Docket Item #10
DEV. SPECIAL USE PERMIT #2008-0011
MOUNT VERNON COMMONS

Planning Commission Meeting
June 3, 2008

ISSUE: Consideration of a request for a time extension of a previously approved development special use permit, with site plan to construct a residential building with ground floor uses, an increase in FAR and a parking reduction.

FIG 5: Site Plan Showing On-Street Parking

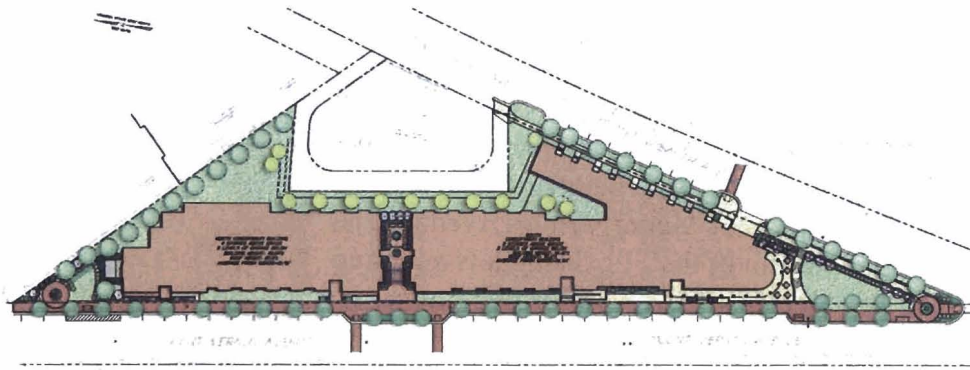
Based on the size of the retail, 16 parking spaces are required; however, the applicant is only proposing to provide 4 retail employee spaces within the underground garage and is requesting a parking reduction of 12 spaces and one loading space for the proposed 3,000 sq. ft. retail space.

Staff does not object to the proposed reduction for the 12 retail parking spaces and one loading space because of the following:

FIG 20: Attachment #1 - Cross-Section through Commonwealth Avenue and Walls on Public Open Space

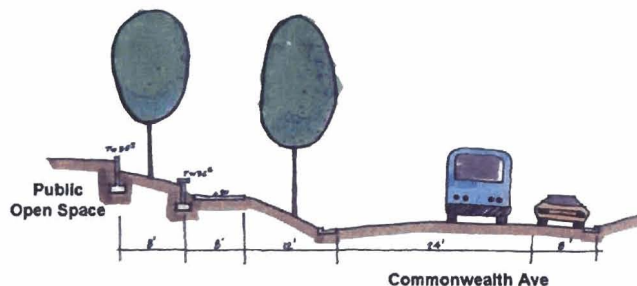
One of the big challenges with the creation of open space at this corner is the change in grade from Mount Vernon to Commonwealth Avenue as well as the associated pedestrian crosswalk at the corner of Mount Vernon Avenue and Commonwealth Avenue. The change in grade requires a 3 to 5 foot retaining wall adjacent to the sidewalk. In addition, at this corner, right hand turns onto northbound Mount Vernon Avenue are a difficult turning movement for vehicles. To address these issues staff recommends that the right-hand turn lane from Commonwealth Avenue to Mount Vernon Avenue be eliminated replaced with open space and landscaping to make the pedestrian environment more attractive, useable and reduce the length of the crosswalk across Commonwealth Avenue. This will likely minimize the need for retaining walls and enable approximately 2,000 sf to be visually added to the corner open space, although the area will remain public right-of-way.

FIG 21: Attachment #2 - North End Open Space

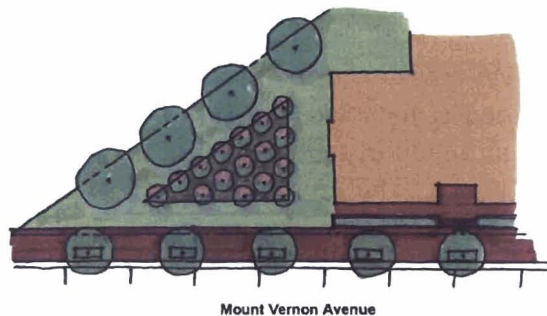
A second open space area will be built at the north end of the site, adjacent to Mount Vernon Avenue. The space is approximately 3,000 sf and a circular brick paver sitting area has been provided with sporadic landscaping. Staff is recommending that the space be simplified with a series of trees that reinforces the triangular shape of the space and the site.

FIG 22: Attachment #3 - Central Courtyard Area

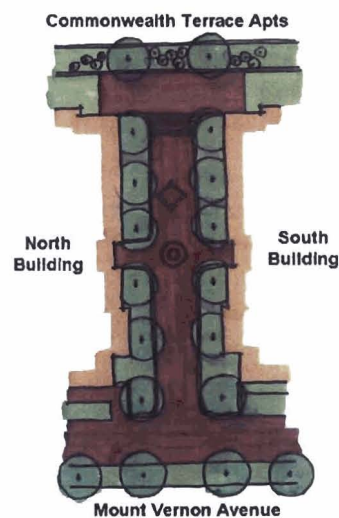
- b. The central courtyard shall be revised to provide less hardscape and paving to be a green landscaped extension of Kennedy Street with small shade trees in planters such as River Birch or Thornless Honeysuckle as generally depicted in *Attachment # 3*. The planter at the end of the courtyard shall be removed and a stairway shall be provided to connect the courtyard with the terrace below, which shall have special paving, benches, lighting and landscaping.

One semi-private open space area has been provided in the middle of the project, at the axis of Kennedy Street. This open space also serves as a mid-block building break with a pergola at the entrance and is visible from Mount Vernon Avenue. The space has special paving, benches, raised planters and landscaping. Staff is recommending that the space be modified to eliminate the pergola and provide upright trees in the space to provide a more visually open green space as a green visual extension of Kennedy Street as previously discussed. Staff is also recommending that the raised planter at the end of the courtyard be eliminated and that steps be provided to the terrace on the east side of the building with a sitting area provided on the terrace.
